UNITED STATES PATENT AND TRADEMARK OFFICE

APPLICATION NO.	FILING DATE	FIRST NAMED INVENTOR	ATTORNEY DOCKET NO.	CONFIRMATION NO.
10/537,708	06/02/2005	Yasunori Shiraki	10921.323USWO	6556
52835 7590 10/27/2010 HAMRE, SCHUMANN, MUELLER & LARSON, P.C. P.O. BOX 2902 MINNEAPOLIS, MN 55402-0902				
EXAMINER				
DINH, BACH T				
ART UNIT		PAPER NUMBER		
1724				
MAIL DATE		DELIVERY MODE		
10/27/2010		PAPER

Office Action Summary

DETAILED ACTION

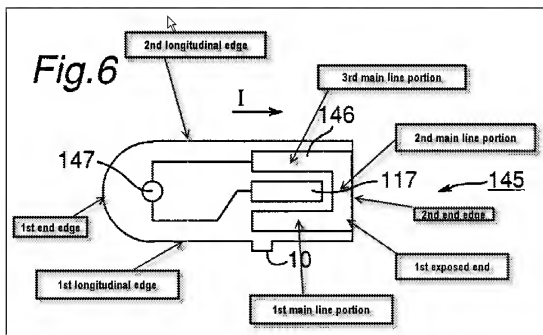
A substrate 10 (figure 6 included below) including a first end edge (as indicated below) and a second end edge (as indicated below) opposite each other;

Electrodes 146 and 117 extending between the first and second edges;

A reagent portion 147 formed on the substrate adjacent to the first end edge (front end edge);

Kawanaka further discloses the electrode 146 is a negative terminal (13:1-8) which is connected to the counter electrode (10:28-34) and the electrode 117 is the positive terminal which is connected to the measuring electrode (10:28-34). Moreover, the terminal 146 is grounded via the electrodes 104 and 103 when the test strip is connected to the apparatus 131 (13:26-34, figure 4);

Wherein the disturbing-noise countermeasure electrode includes a first exposed end, a first main line portion and a second main line portion extending in the manner required by current claim as indicated above. With respect to the limitation regarding the third main line portion in conjunction with the indefinite rejection above, figure 6 of

Kawanaka shows that the third main line portion is connected to the second main line portion; therefore, the third main line portion extending from the second main line portion toward the second end edge of the substrate (the third main line portion indicated above extend in all direction, including the direction of the second end edge) along the second longitudinal edge of the substrate;

Wherein the working electrode 117 includes a second exposed end located adjacent to the second end edge of the substrate (figure 6 above) and extends from the second exposed end toward the first end edge of the substrate between the first and third main line portions of the disturbing-noise countermeasure electrode (figure 6 above); and

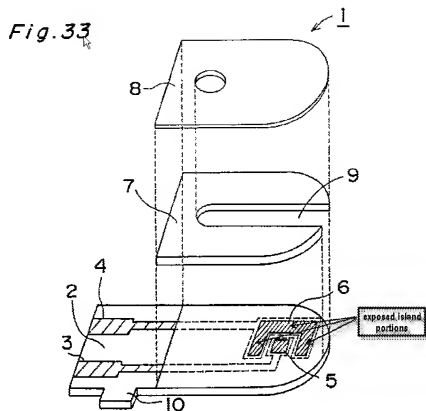
Addressing claim 11, in figure 33, Kawanaka discloses a flow path 9 and an air vent provided in the cover 8 (12:48-60, the test strip 145 has the same configuration as the test strip 1 disclosed in figure 33). Although the biosensor shown in figure 33 is labeled as prior art, it is Examiner's interpretation and position that the flow path 9 and air vent (the combination of the channel 9 and the aperture on layer 8 constitute the air vent) of figure 33 are applicable to and present in the biosensor shown in figure 6 of Kawanaka.

Addressing claim 12, in figure 33, Kawanaka discloses the counter electrode 6 is connected to the air vent; therefore, any disturbing noise coming through the air vent would inherently come into contact with the counter electrode. Hence, Kawanaka discloses the claimed input portion according to the claim language. Alternatively, in the

In figure 33, Kawanaka discloses the counter electrode 6 or the disturbing-noise countermeasure electrode further include an island provided directly below the air vent and partially covered by an insulating film (the combination of the channel 9 and the aperture of layer 8 constitute the air vent; therefore, the portions as indicated in figure 33 below are portions of the island disposed directly below the air vent and partially covered by an insulating film); wherein, the insulating film includes an opening for partially exposing the island to serve as the noise inputting exposed portion (please see figure 33 below, the exposed portion of the island are susceptible to static energy as discussed above).

With respect to the limitation of claims 15-16, the combination of layers 7 and 8 constitute the cover which is bonded to the substrate and in which the air vent is formed and the exposed portion of the counter electrode surrounds the air vent (figure 33).

Addressing claim 17, in figure 33, the counter electrode 6 surrounds the working electrode 5. Therefore, due to the fact that Kawanaka focuses more on the arrangement of the terminal ends of the electrodes, Kawanaka does not disclose in detail the arrangement of the counter electrode and the working electrode in figure 6. Therefore, it is Examiner's position that the counter electrode in figure 6 surrounds the working electrode in the manner shown in figure 33.
